**Evaluation of Peach Bottom
Atomic Power Station Units 2 and 3
Offsite Dose Calculation Manual, Revision 5**

Docket No. 50-277, Facility License No. DPR-44
Docket No. 50-278, Facility License No. DPR-56

Published July 1995

Prepared for the
Division of Radiation Safety and Safeguards
Office of Nuclear Reactor Regulation
U.S. Nuclear Regulatory Commission
Washington, D.C. 20555
Under DOE Contract DE-AC07-94ID13223
FIN E2084

Figure 1. Liquid radwaste treatment system at PBAPS.

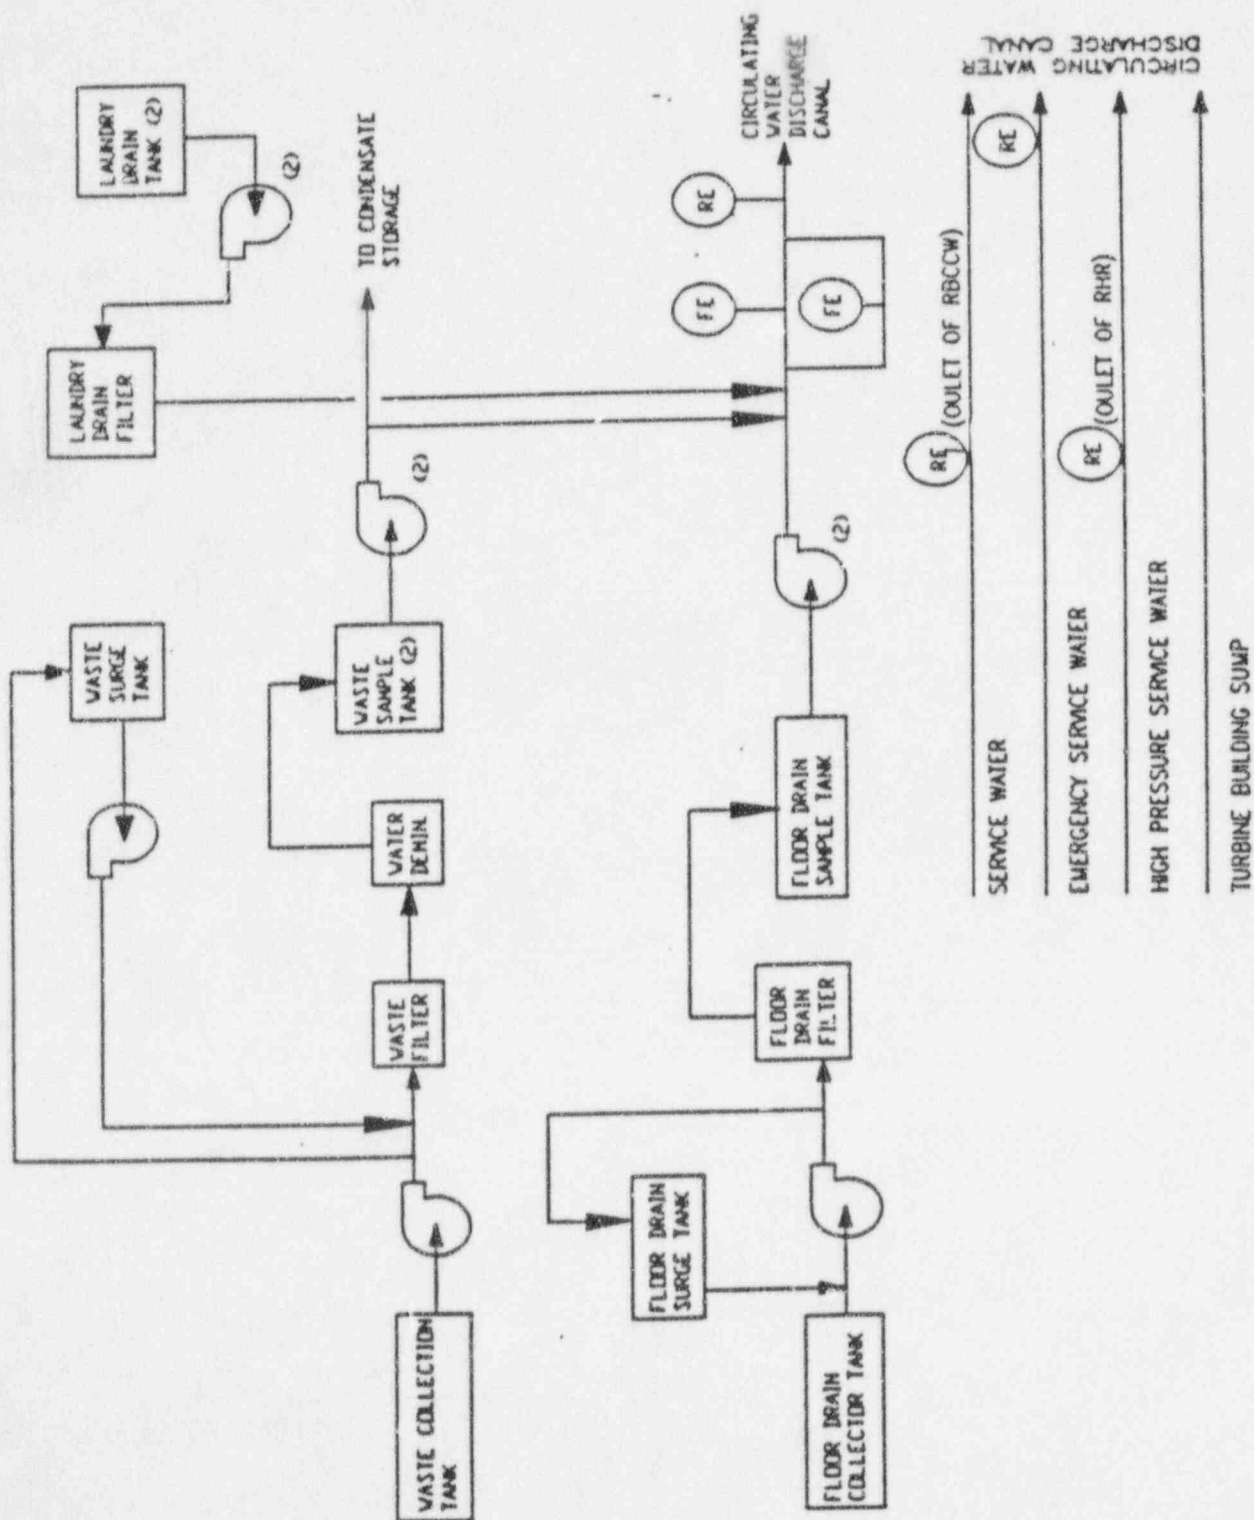
Figure 1 shows a schematic diagram of the PBAPS Units 2 and 3 liquid radwaste treatment system. The diagram clearly shows the source terms and liquid flow path, and associated monitors. However, it should also identify the monitor labels and indicate which of these monitors incorporates a termination of release capability in addition to the provision for alarms. In addition, it should be made clear whether all potential release pathways are monitored and are included in the ODCM calculations.

1. Figure 1 shows a schematic diagram of the PBAPS Units 2 and 3 liquid radwaste treatment system. The diagram clearly shows the source terms and liquid flow path, and associated monitors. It should also identify the monitor labels and indicate which of these monitors incorporate a flow shutoff capability in addition to the provision of alarms.
2. Radioactive gaseous effluents from PBAPS Units 2 and 3 are collected by the gaseous radwaste system and released to the atmosphere through the plant stack and reactor building vent stack. The gaseous effluent sources from both units are the main condenser air ejectors, startup pumps, and the gland seal condenser. However, the roof vent and associated monitor are not shown in the diagram.

Figure 2. Off-gas radwaste treatment system at PBAPS.

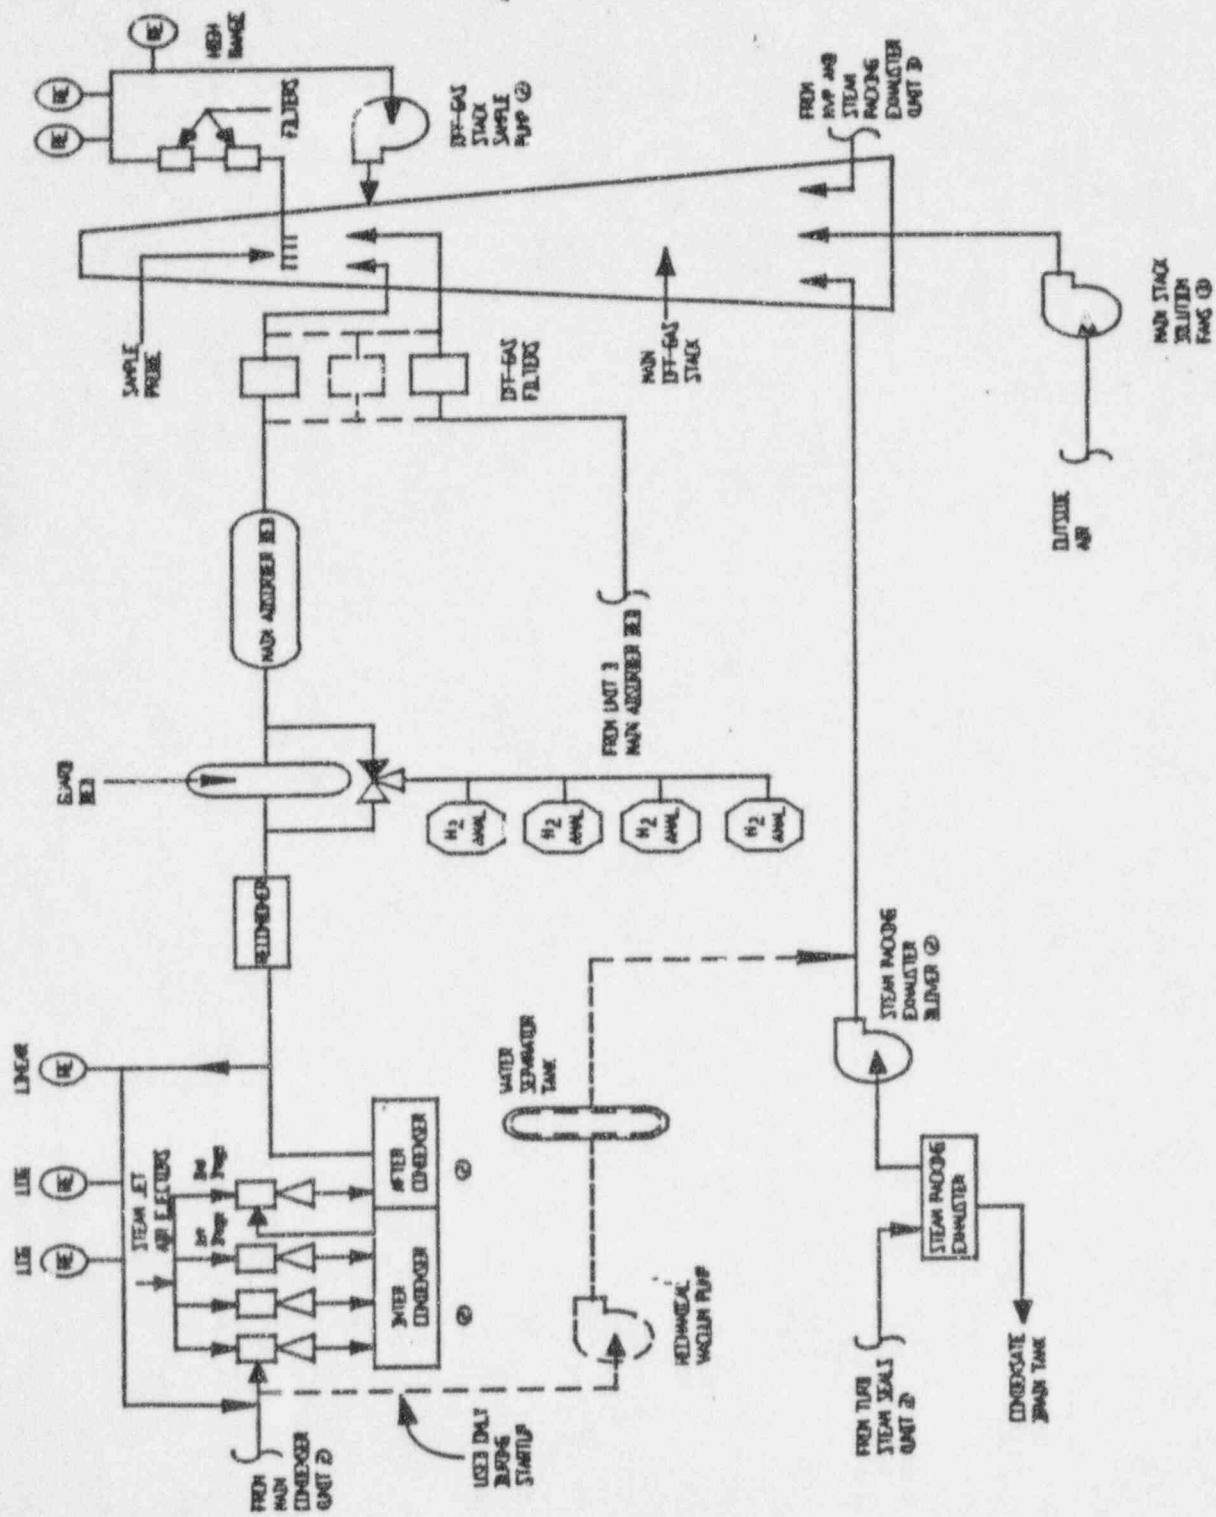
Radioactive gaseous effluents from PBAPS Units 2 and 3 are collected by the gaseous radwaste system and released to the atmosphere through the plant stack (Figure 2). In addition, there are radioactive gaseous releases from the ventilation exhaust waste treatment system, as shown in Figure 3. The gaseous effluent sources from both units are the main condenser air ejectors, the startup pumps, and the gland seal condenser. However, the roof vent and associated monitor are not shown in the diagram. The height of the plant vent stack should be specified in the ODCM to support the calculation of air doses.

1. The filtration system associated with the reactor building equipment cell (U2), recombiner building (U2), turbine building equipment cell (U2), radwaste equipment cell (U2), chemistry laboratory (U2), and fume hood (U2) should be described in the ODCM.
2. The ODCM should include a description of the gaseous radwaste system in addition to the schematic diagram.

1. The roof vent and its associated monitor(s) should be shown in the ODCM.

Figure 3. Ventilation exhaust waste treatment system at PBAPS.

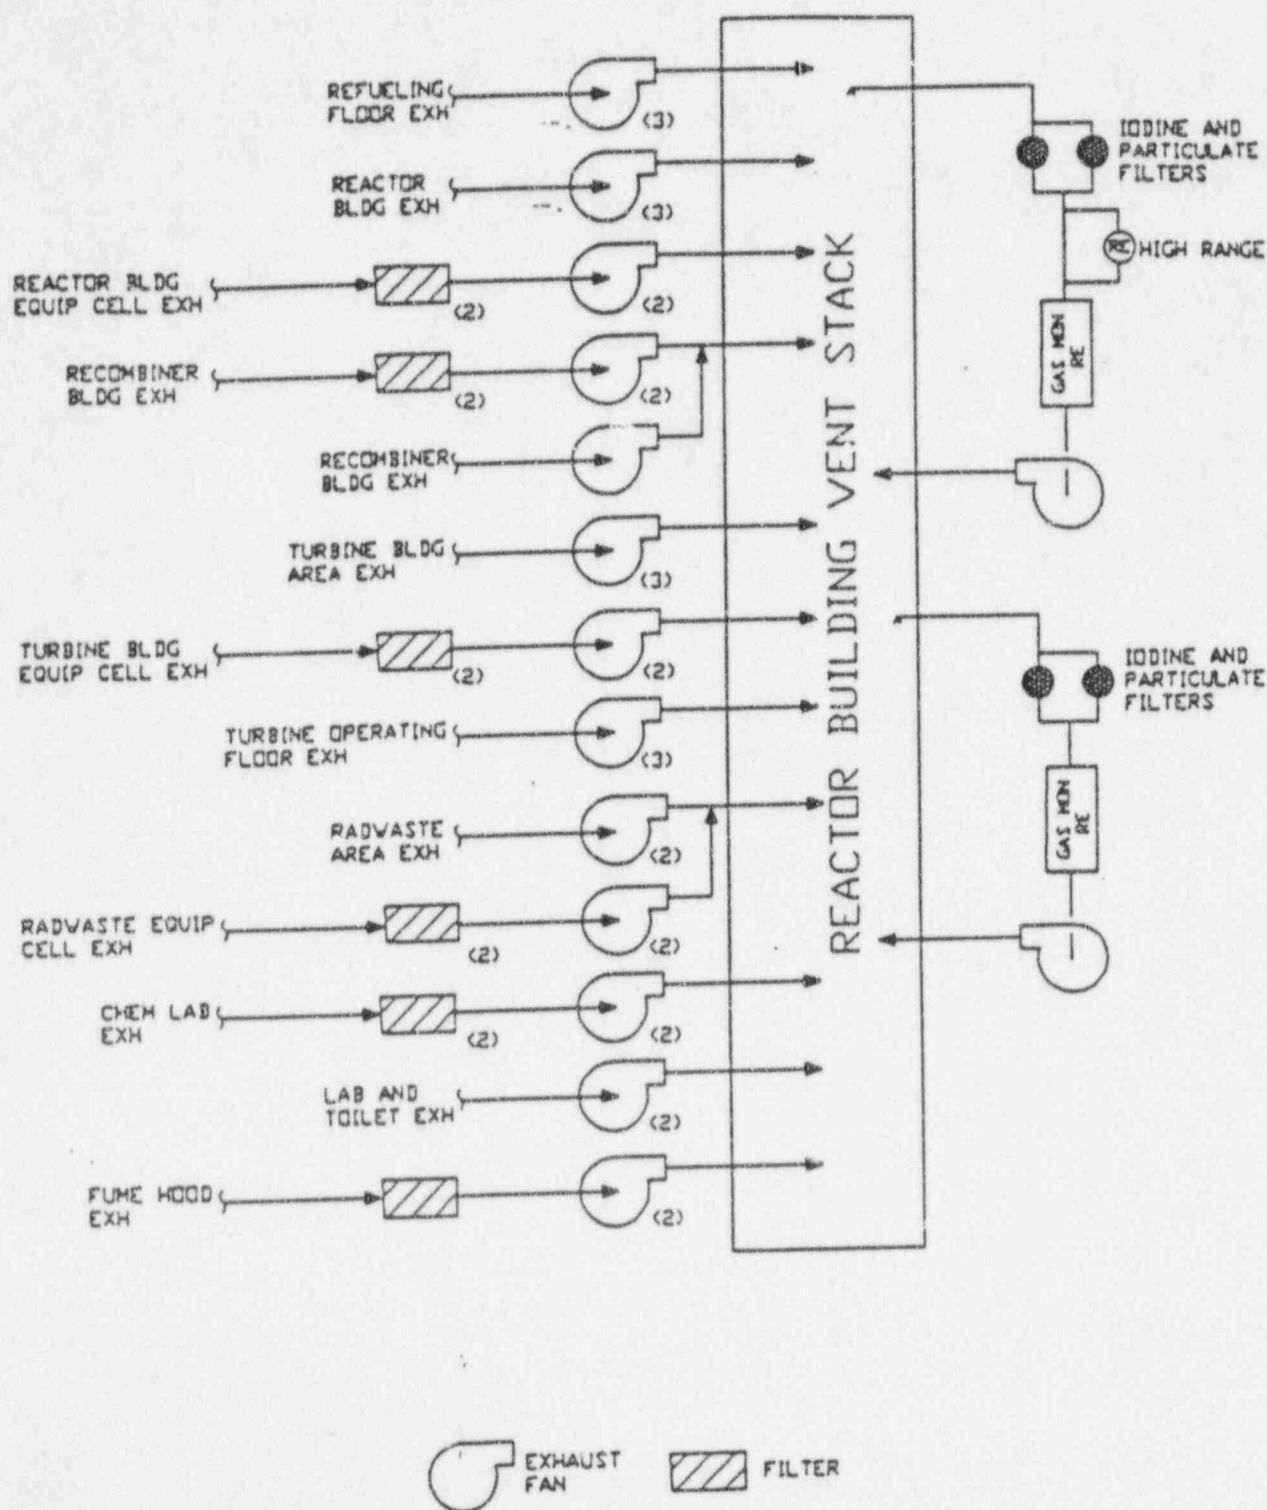
radwaste equipment cell (U2), chemistry laboratory (U2), laboratory and toilet (U2), and fume hood (U2). Exhausts from the following sources are filtered prior to release into the reactor building vent stack: the reactor building equipment cell (U2), recombiner building (U2), turbine building equipment cell (U2), radwaste equipment cell (U2), chemistry laboratory (U2), and fume hood (U2).
